MODIFICATION RECOMMENDED

6674A-12

S E R V I C E N O T E

6674A DC POWER SUPPLY, 0-60 V, 0-35 A, 2100 W. GPIB CONTROLLED.

Figure 5

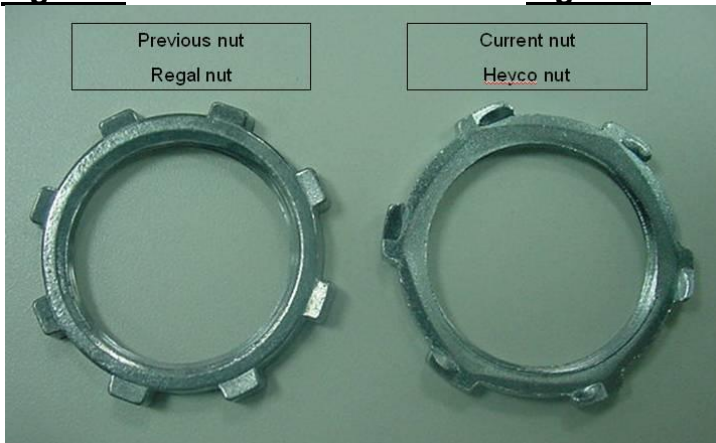
Figures 3 & 5 is representative of a not without locking ribs.

Figure 3 Regal Non locking Nut

Figure 4 Heyco locking Nut

Figures 4 & 6 is representative of a nut with locking ribs.

The entire AC **INPUT SAFETY COVER** P/N 5040-1676 should be replaced.
